Multi-Pollutant Emissions Standards for Model Years 2027 and Later Light-Duty and Medium-Duty Vehicles

Response to Comments

Assessment and Standards Division
Office of Transportation and Air Quality
U.S. Environmental Protection Agency

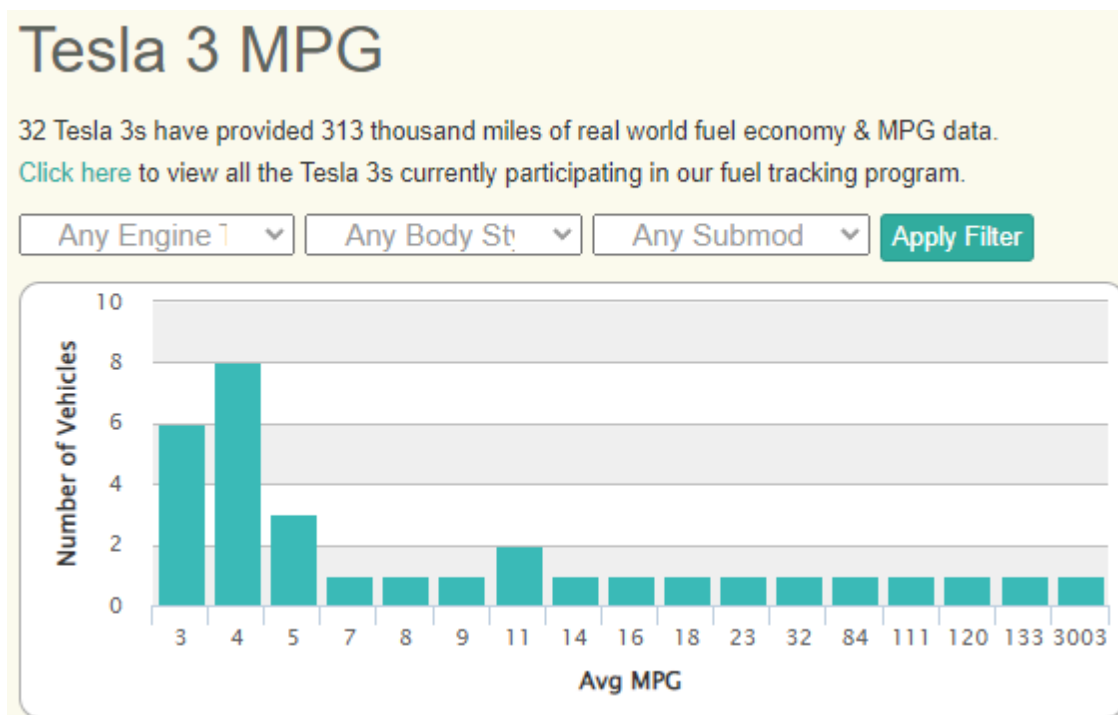
We have also observed that the proposal excludes several relevant peer-reviewed publications, including papers by Toyota²³⁰ and UC Davis²³¹ that provide counter-balancing arguments to the claims that the SAE FUF is no longer appropriate. The lack of consideration of other studies, such as these, suggests that further consideration is required. [EPA-HQ-OAR-2022-0829-0701, pp. 124-127]

For its U.S. analysis ICCT, inspired by the European analysis, evaluated two data sources: user-reported data from Fuely.com, and OBD data from the California Bureau of Automotive Repair (BAR). For the Proposed Rule, EPA has taken the ICCT datasets and performed their own analysis, which is essentially a copy of ICCT’s work. The PHEV data analysis should include nationwide usage data and be peer-reviewed before it is used in rulemaking. [EPA-HQ-OAR-2022-0829-0701, pp. 124-127]

SEE ORIGINAL COMMENT FOR Figure 36: Fuely.com data for 2019 Chevrolet Volt.

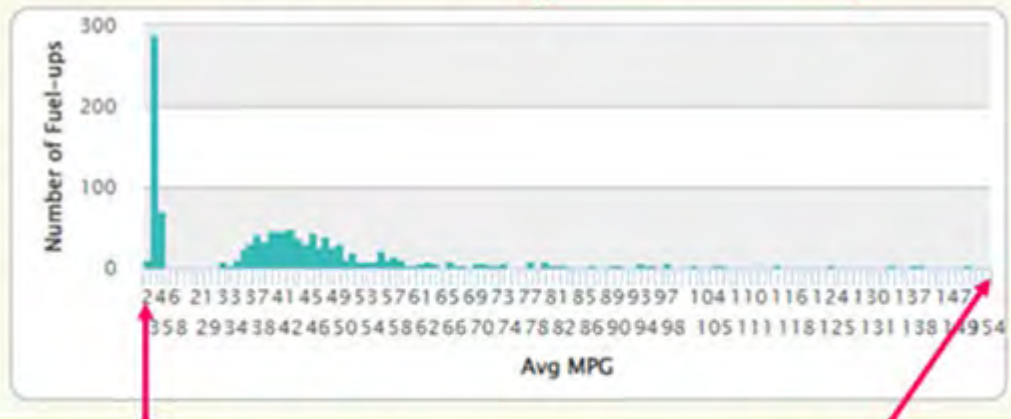
As seen from the example above, electricity consumption values for a Model 3 and other BEVs are mistaken for gasoline consumption, resulting in a distinguishable pattern of impossibly low efficiency refueling events alongside normal refueling events. Data entry errors like this would cause the Fuely web application to severely over-estimate the fuel consumption of PHEVs, therefore severely under-estimating the derived utility factor. [EPA-HQ-OAR-2022-0829-0701, pp. 124-127]

The refueling events for PHEVs having an accurately high charging frequency and utility factor have been excluded as outliers by the Fuely application because their fuel economy is deemed too high. For example, a regularly charged Chevrolet Volt can attain 200+ MPG which can be filtered from the distribution of re-fuel events because the value lies beyond Fuely’s 3-sigma screening limit that is applied to fleet average MPG (see Figure 36 below). These omissions further mischaracterize PHEV real-world fleet performance. [EPA-HQ-OAR-2022-0829-0701, pp. 124-127]

[See original for graph titled “Figure 2. Plug in Hybrid Electric Vehicle Utility Factors from Bureau of Automotive Repair Data.”] [EPA-HQ-OAR-2022-0829-0780, pp. 20-22]

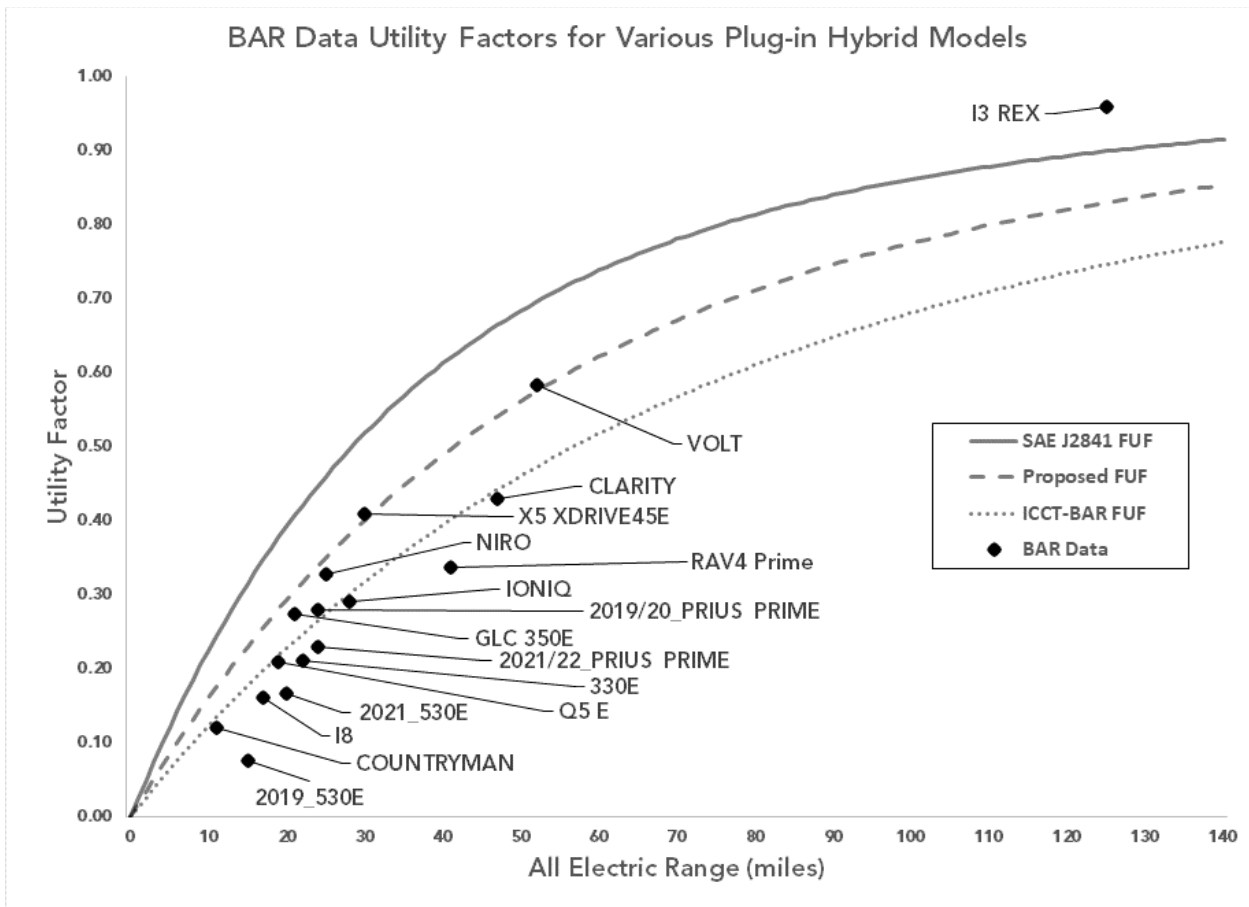
Figure 2 and Table 1 present CARB’s results. As shown in Figure 2, most recent PHEV models fall below both the SAE J2841 22 curve and U.S. EPA’s proposed FUF curve. Rather, the ICCT-BAR FUF curve that U.S. EPA’s presents—but is not proposing to use—appears to be better correlated with actual real-world electric operation in these cases, and CARB’s analysis reaffirms ICCT’s original analysis. The notable exceptions are two vehicle models with unique architectures and higher all-electric ranges: the 2019 Chevrolet Volt (53-mile label range) and the 2019 BMW i3 REX (126-mile label range).²³ The 2019 Volt performed nearly identically to the U.S. EPA proposed FUF curve, and the i3 REX delivered more zero-emission miles than would be assigned under the SAE J2841 FUF. Notably, both of these models have been discontinued and used designs like a range-extender concept where the battery had to be depleted before the gasoline engine could be utilized. More recent models with similar all-electric capabilities like the Toyota RAV4 Prime and the Honda Clarity PHEV both averaged at or below even the lower ICCT-BAR FUF curve. [EPA-HQ-OAR-2022-0829-0780, pp. 20-22]

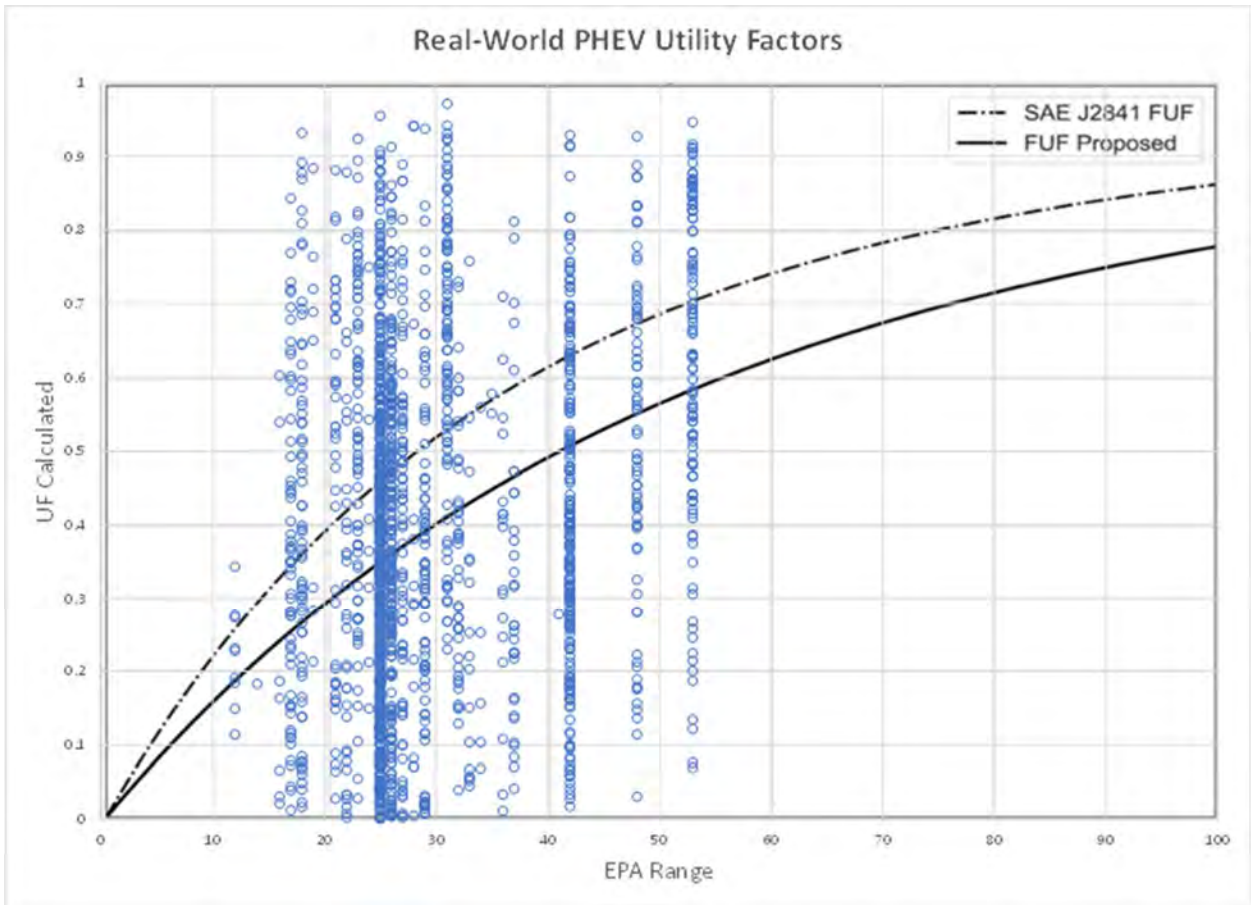
Figure 1 illustrates the set of individual vehicle-level UFs that are derived from an updated data pull from BAR. Of course, the data are extremely scattered and do not illustrate the validity of the UF curves for either the SAE J2841 FUF or the proposed FUF. When EPA or ICCT perform least-squares regression to derive a particular UF curve, they must calculate the confidence interval around the parameter estimates. When we perform that regression with vehicle models' pooled averages, we find that this dataset provides no evidence that the EPA FUF model is more representative than the SAEJ2841 model. [EPA-HQ-OAR-2022-0829-0646, pp. 14-18]

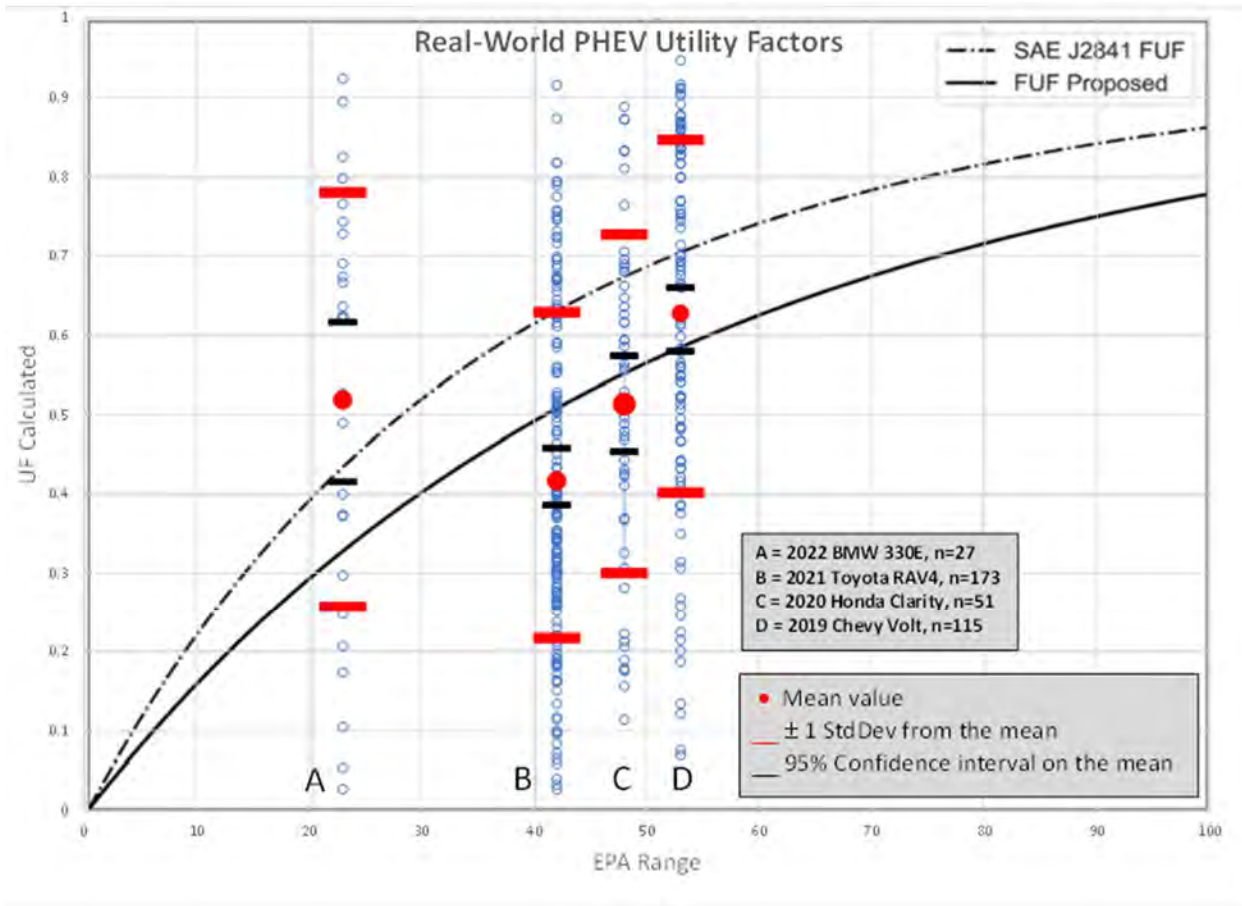
To illustrate this point more visually, Figure 2 provides additional statistical detail for some selected vehicle models. Figure 2 illustrates the wide dispersion of measured individual UFs and shows that the 95% confidence intervals on the mean value may or may not encompass any particular pre-derived response curve. [EPA-HQ-OAR-2022-0829-0646, pp. 14-18]

Figure 1: Projected U.S. EV Battery Demand and Announced Battery Production Capacity (2022-2032)

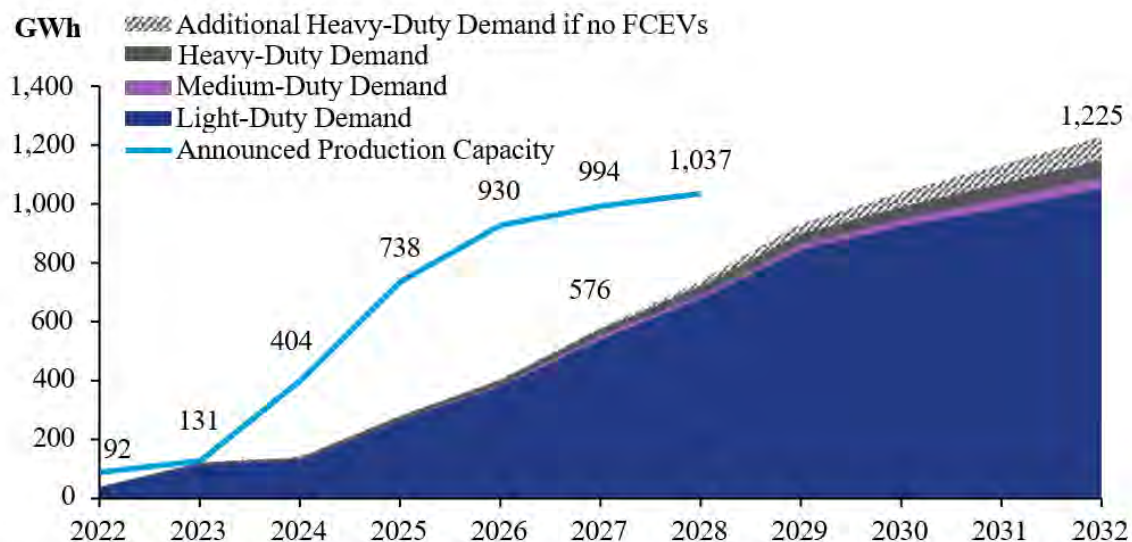
EDF used the EPA's projections for EV adoption and associated battery demand through 2030.ⁱⁱ Roughly 90% of the potential EV battery demand is from light-duty (passenger) vehicles. Potential demand for batteries in medium-duty vehicles (large pickup trucks and vans) and heavy-duty vehicles (delivery trucks, step vans, semi-trucks, buses, etc.) is much smaller.

Figure 1 shows EPA projected battery demand by segment:
